Citation: Enercorp Engineered Solutions Inc (Re), 2024 CACP 4

Commissioner's Decision #1663

Application No. 2929643

- [1] This recommendation concerns the review of rejected patent application number 2,929,643, which is entitled “Apparatus, system and method for separating sand and other solids from oil and other fluids” and is owned by Enercorp Engineered Solutions Inc. The Patent Appeal Board (the Board) has reviewed the rejected application pursuant to paragraph 199(3)(c) of the *Patent Rules* (SOR/2019–251). As explained below, we recommend that the Commissioner of Patents refuse the application.

Figure 4-2. Horizontal separator schematic.

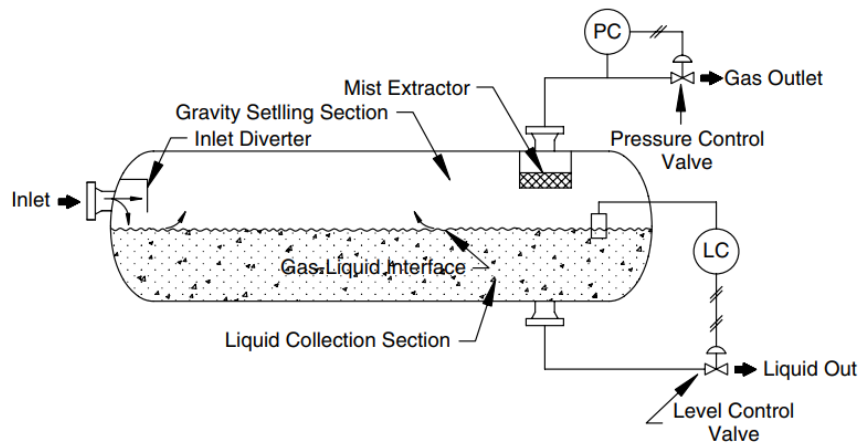
However, as set out above under CGK, using a mist extractor near the outlet of horizontal separators like the one in D1 was well known. For example, Figure 4-2 from the Arnold & Stewart handbook shows such a configuration having a mist extractor parallel to the vessel axis that is held in place by a perpendicular support structure:

As part of the CGK taken from the Arnold & Stewart handbook, mist extractors such as illustrated in Figure 4-2 above, may be baffles, mist pads or wire-mesh cartridge filters and selecting an appropriate mist extractor would consider factors such as the nature of the fluid and cost, wire-mesh pads being the cheapest but most susceptible to plugging with gas hydrates (Arnold & Stewart page 187).

As is evident from Figure 4-2 of the Arnold & Stewart handbook, it was well known to force moving gas with entrained solids around a support structure perpendicular to the longitudinal axis of a horizontal separator, and for the gas to then flow through a mist extractor (e.g., a baffle in the form of a perforated plate) oriented parallel to the longitudinal axis of the separator.

In light of the above, it is our preliminary view that it would have been obvious to the skilled person, having knowledge of D1 and possessing the relevant CGK, to make modifications to the structure of the D1 baffle as needed depending on the characteristics of the fluid and overall separation system configuration. Using a baffle in the form of a perforated plate as a mist extractor near the outlet of a horizontal separator and supporting such a structure so that fluid must flow around the support structure and up through the mist extractor were options that were part of the skilled person’s CGK. The Applicant has not described any particular advantages in using their claimed configuration beyond those that would have been expected based on the CGK and our preliminary view is that the skilled person would not consider it as being associated with any degree of inventive ingenuity.
